Appendix B – Written Comments on Draft EIS

Appendix B contains all written comments received on the Draft EIS.

Figure 13-3 - Map of Recreational Facilities along the Eielson Alternative Segments

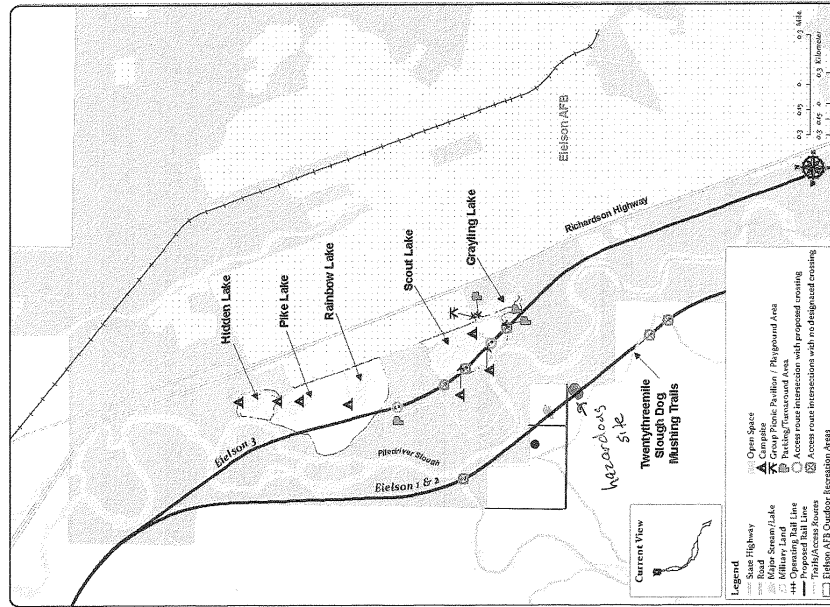
- Land Use
 - Your figures show segment 3 affects about the same area of private land as segment 1. I question how you came up with the amount of private and agricultural land affected. Because the railroad crosses our property in two places I would say it would directly affect at least 5 acres of agricultural land. In my mind if the railroad crosses designated agriculture land it has affected agricultural use whether or not the land is cleared. I think closer review would reveal the number of agricultural land affected to be much higher. Segment 3 does not cross any designated agricultural land.

2-12 (Figure) Richardson Highway and Salcha School Relocation

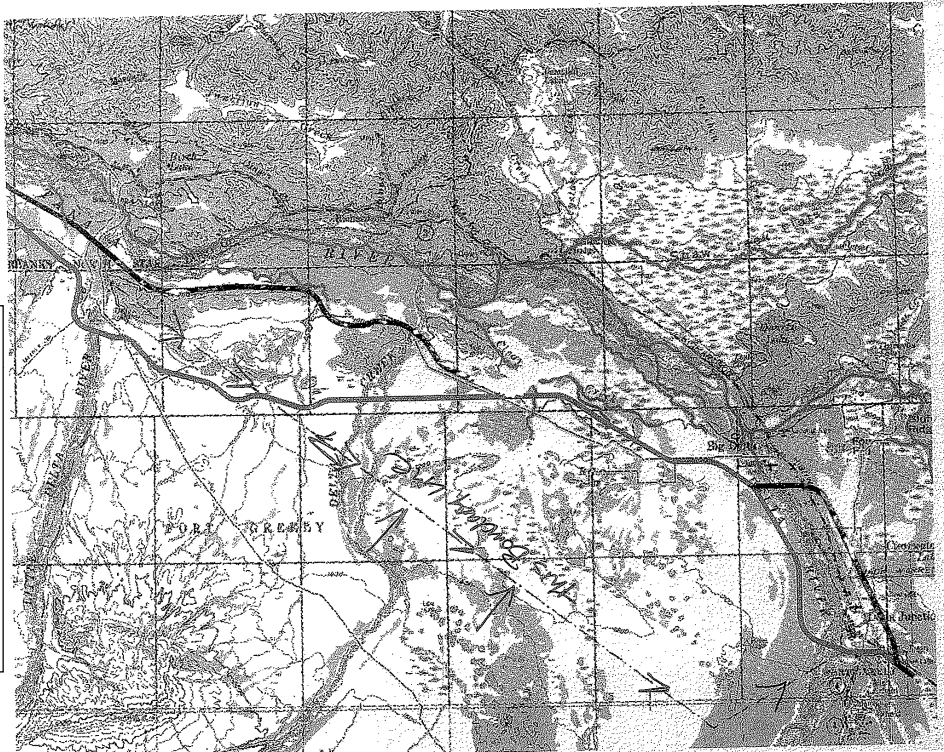
FNSB opposes the Salcha 2 Alignment, which would require the relocation of Salcha Elementary School. This would be a severe hardship for the Salcha Community, as this is the only elementary school in the area.

In addition, a native cemetery for the Salchaket Band of Athabascan Indians is located on the south end of the ridge as well as an archeological site. Both have significant importance to the history and culture of the State of Alaska and should be avoided.
